Project	IEEE 802.16 Broadband Wireless Access Working Group http://ieee802.org/16 >		
Title	Correction for UL-MAP processing time mismatch		
Date Submitted	2004-08-19		
Source(s)	Intel.		
	Yuval Lomnitz	Yuval.Lomnitz@intel.com	
	Yigal Eliaspur	Yigal.Eliaspur@intel.com	
	Noam Kogan		
	Dov Andelman		
Re:	IEEE P802.16REVd/D5-2004		
Abstract	Correct UL MAP processing time definition		
Purpose	Adopt changes to definition of UL-MAP processing time (Tproc) in OFDMA		
Notice	This document has been prepared to assist IEEE 802.16. It is offered as a basis for discussion and is not binding on the contributing individual(s) or organization(s). The material in this document is subject to change in form and content after further study. The contributor(s) reserve(s) the right to add, amend or withdraw material contained herein.		
Release	The contributor grants a free, irrevocable license to the IEEE to incorporate material contained in this contribution, and any modifications thereof, in the creation of an IEEE Standards publication; to copyright in the IEEE's name any IEEE Standards publication even though it may include portions of this contribution; and at the IEEE's sole discretion to permit

Figure 1 – UL-MAP processing example: TDD

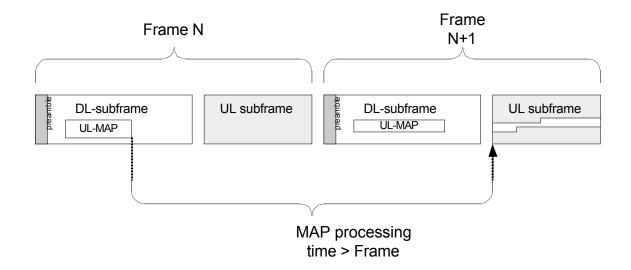
In order to prevent contradictions we suggest to define UL-MAP processing time as proportion of frame duration. The logic behind this definition is that most of the work on UL-MAP is proportional to the potential amount of data to transmit, which is proportional to frame duration. This emposes the minimum restriction on the SS required for system operation.

The proposed definition is: $T_{proc} = T_f$ (frame duration)

For TDD this allows any location of the UL-MAP if the DL/UL ratio is constant, while allowing the BS to use dynamic DL/UL ratio by locating the UL-MAP at the start of the frame.
